NRC Staff Feedback on NEI 25-08

“Graded Approach to Seismic Hazard Analysis and
Corresponding Site Investigations for Licensing Power Plants”

NEI 25-08 Overview ([ML25335A211](#))

Figure 1: Framework for Graded Seismic Hazard and Site Characterization

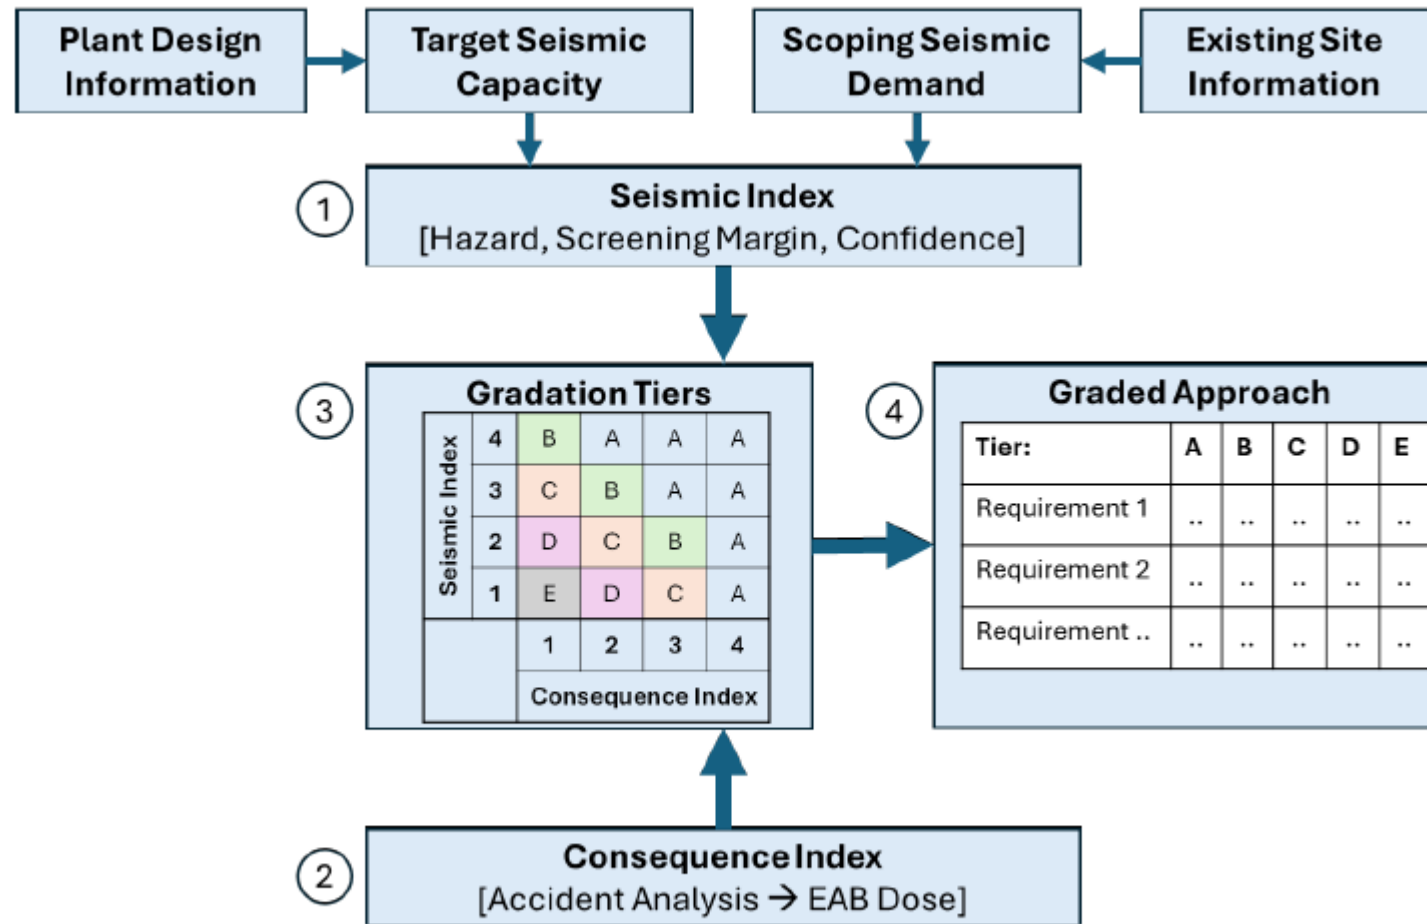
Use of proposed thresholds do not seem consistent and conservative across all consequence indices

Example Site Response Spectra

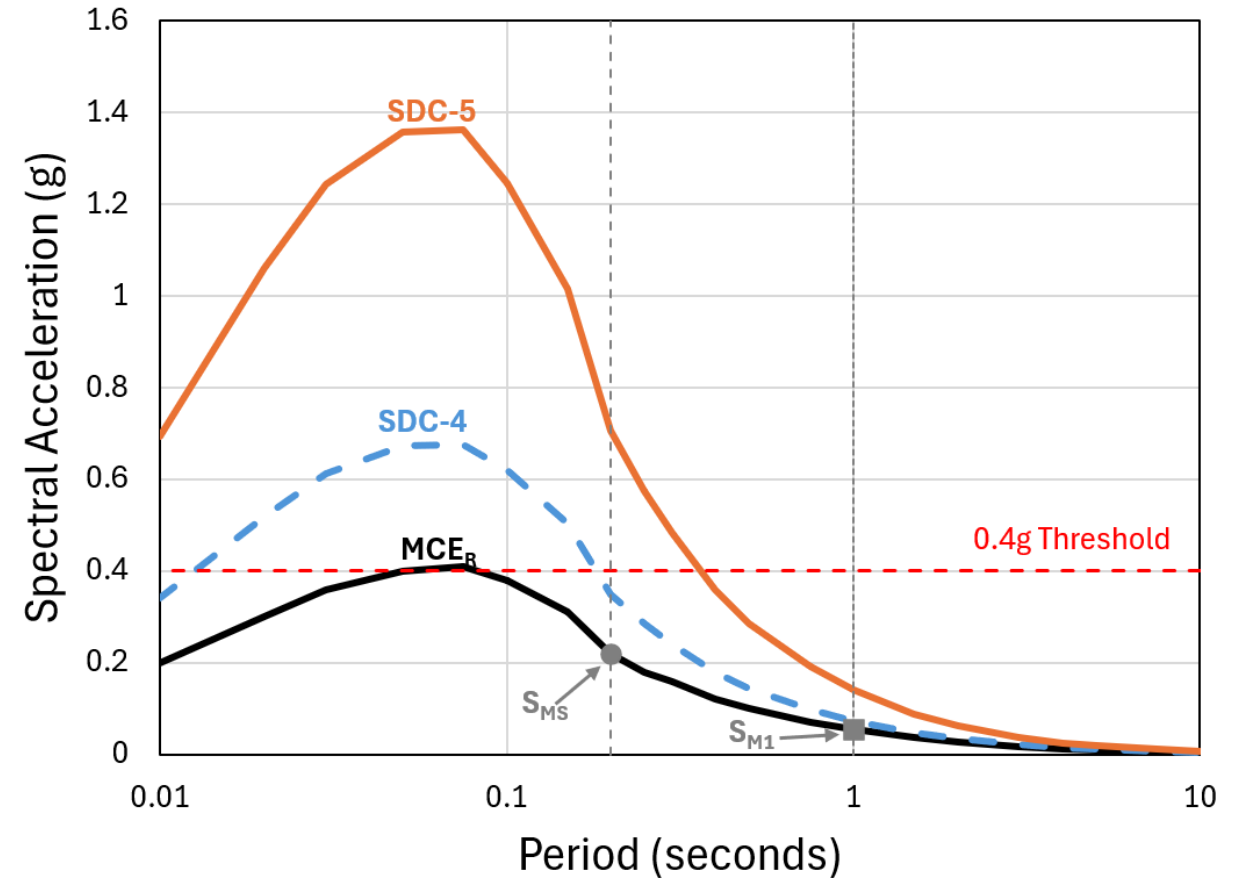
SDC-4 and SDC-5 spectra exceed 0.4g EPRI low hazard threshold (**Medium or High Hazard Level**)

Example Site Response Spectra

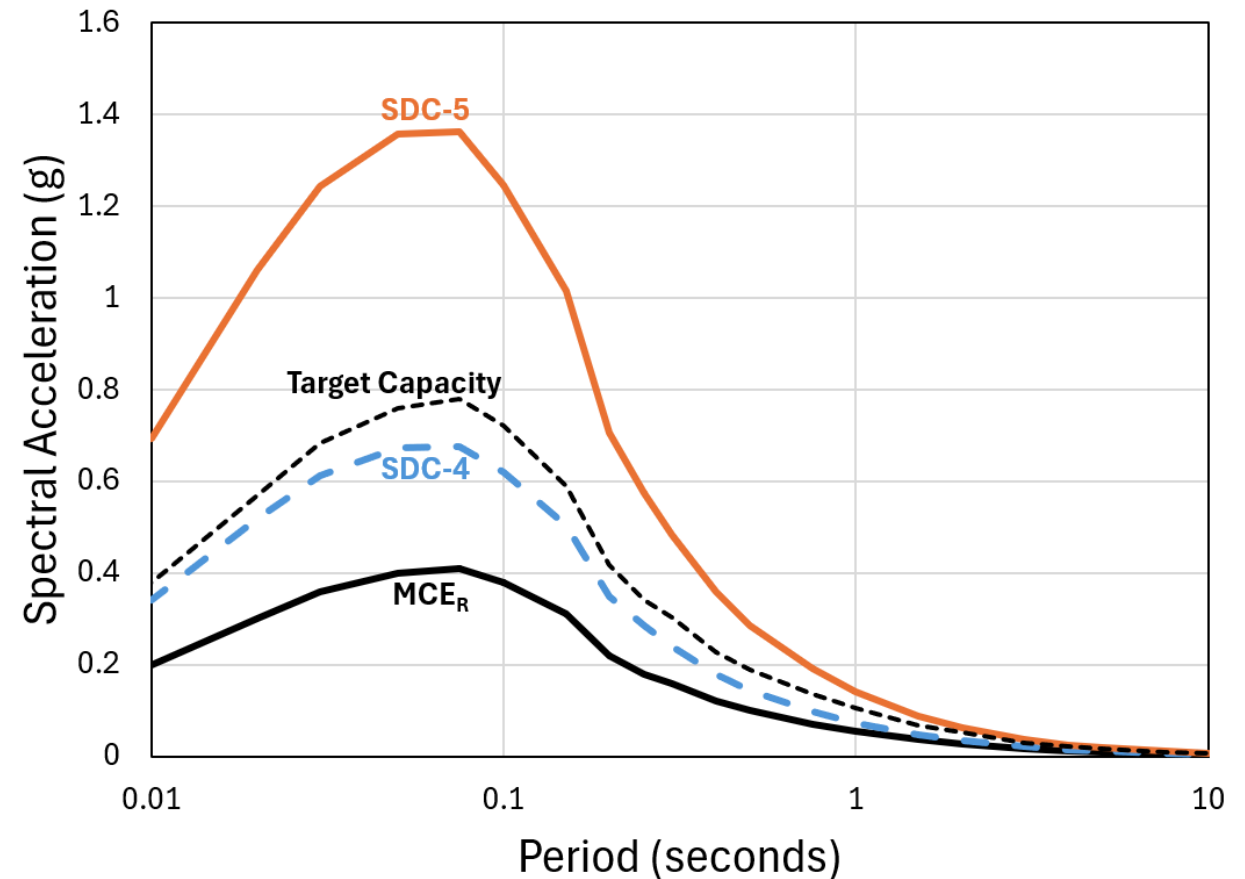
Response Spectrum	M_p	Seismic Margin
MCE_R	1.9	High
SDC-4 GMRS	1.2	Low
SDC-5 GMRS	0.6	Low

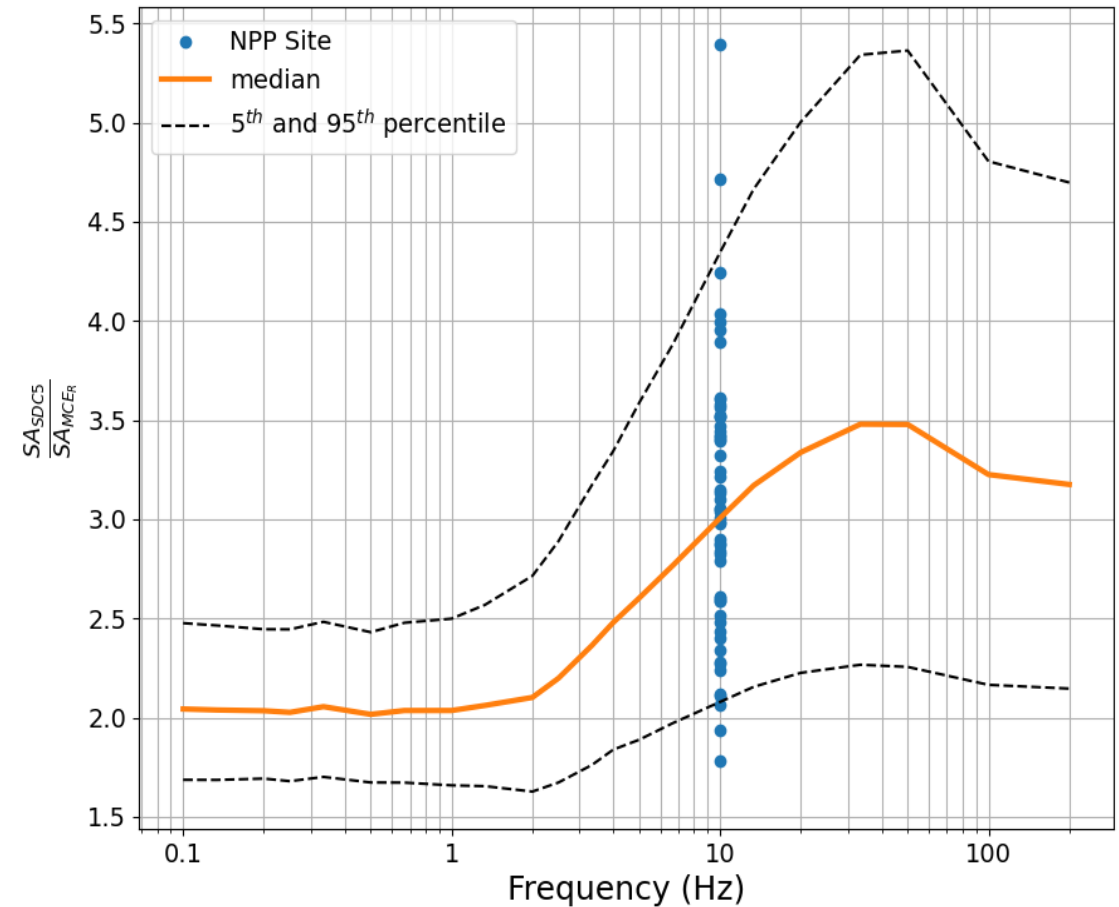
- Changing target performance goal based on seismic index does not seem consistent with ANS and ASCE standards
- Tier A may only be appropriate for the lowest consequence (highest consequence index) and where a target performance goal of 2×10^{-4} per year is acceptable
